Technical Service Bulletin: TSB190225	Released Date: 24-Jan-2020
Campaign #4035: Fix for C100D2RE Generator Set Paralleling Control Wiring Issue

Campaign #4035: Fix for C100D2RE Generator Set Paralleling Control Wiring Issue

Figure 1, Harness A054R546 with P70 and J40 highlighted

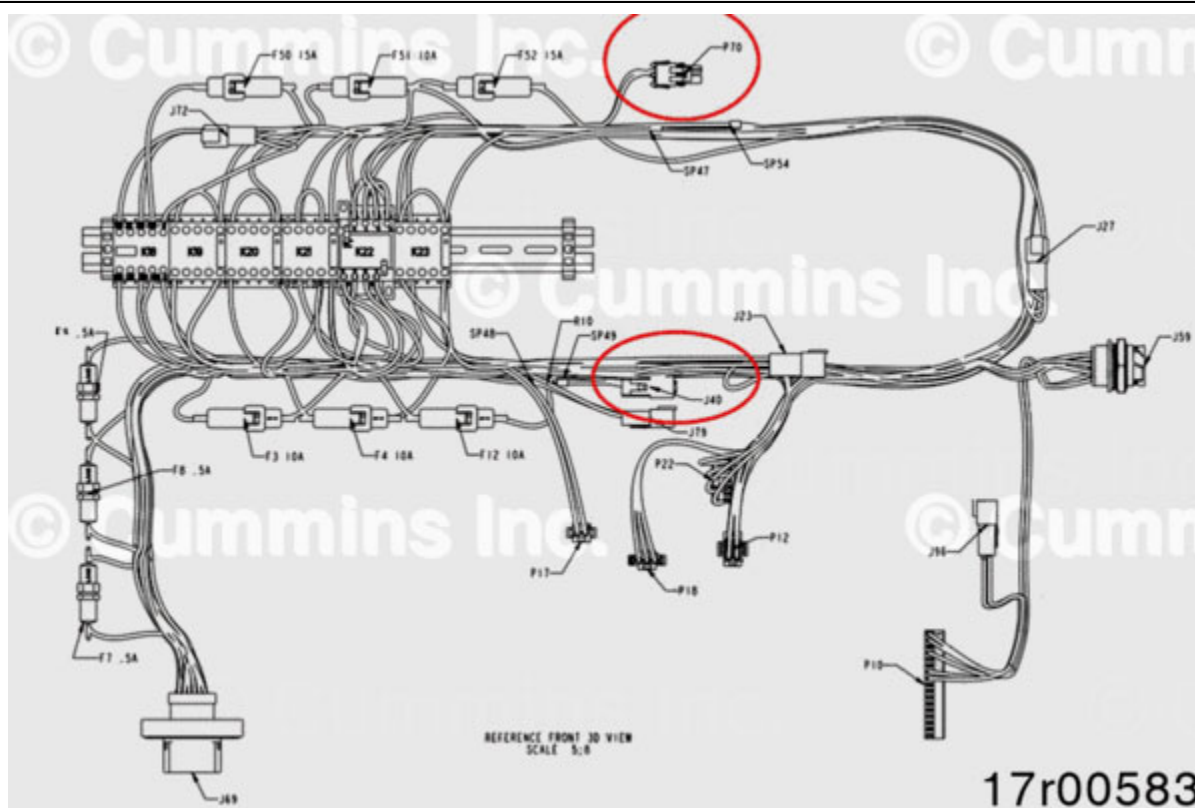
When a C100D2RE generator set is attempted to parallel with a C150, C200 or C275 generator set, the B+ (24 VDC) on the two units short with each other, as a result of which the units cannot be paralleled, and temperature of the paralleling cable rises.

- Due to a design error in C100D2RE generator set harness, paralleling C100 with any other models causes the B+ (24 VDC) from one unit to be shorted to B+ on the other unit

On the harness of C100D2RE (PN: A054R546) shown in Figure 1 below:

1. Swap P70-A and P70-B
2. Swap J40-1 and J40-2

1. From J66A-12 to K23A-1
2. From J66A-13 to K23A-2
3. From TB3-5 to K20A-2
4. From TB3-11 to K20-14 (resistance value should be 10k ohm)

Figure 2, Location of connectors P70 and J40 on harness

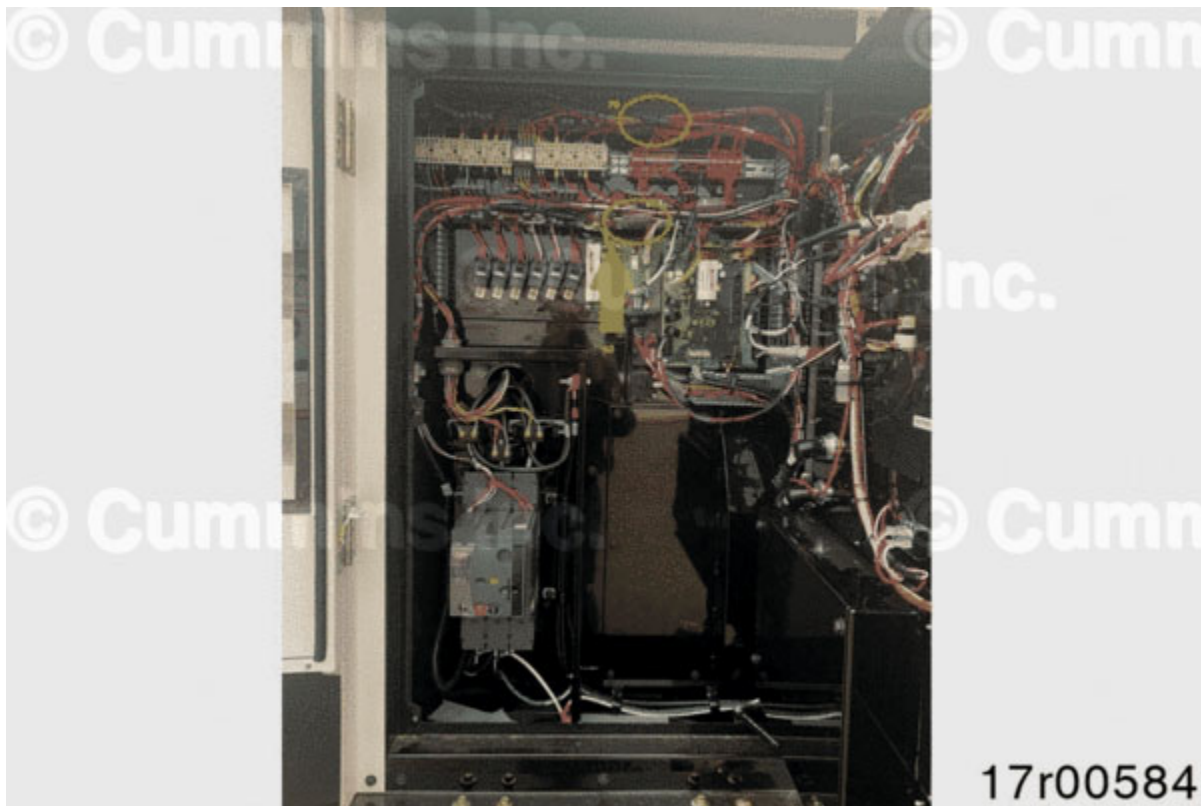
The harness is in the front panel inside the top rack of generator set. To locate connectors P70 and J40 with respect to the harness, refer to Figure 2.
